IREDELL COUNTY HEALTH DEPARTMENT

(SEPTIC TANK) IMPROVEMENTS PERMIT AND CERTIFICATE OF COMPLETION

OWNER OR CONTRACTOR WESLEY ROBINSON

Plot of System

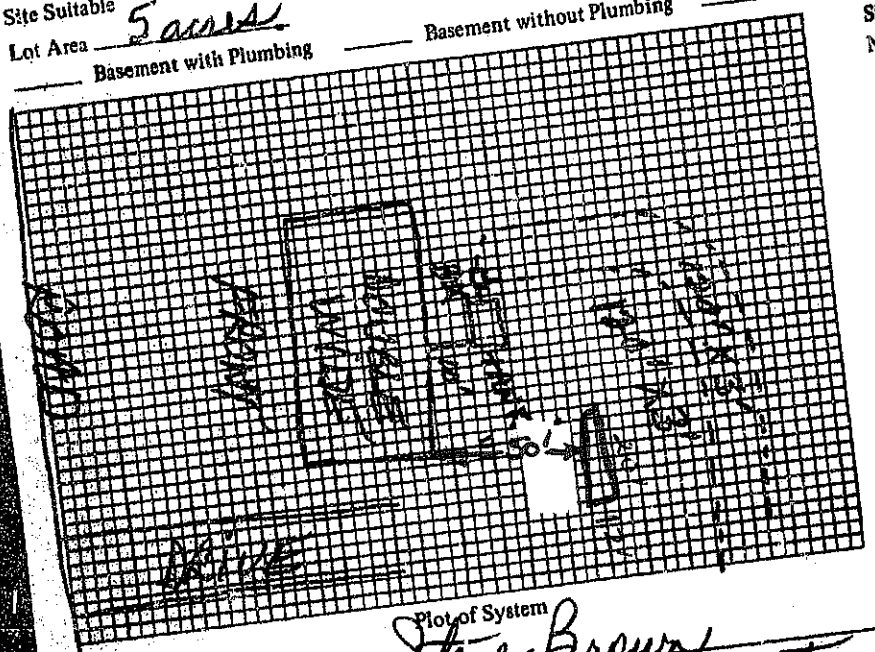
Location of the proposed Utility Building addition does not appear to impact the existing on-site septic system.**NOTE: Keep NEW 5' from system
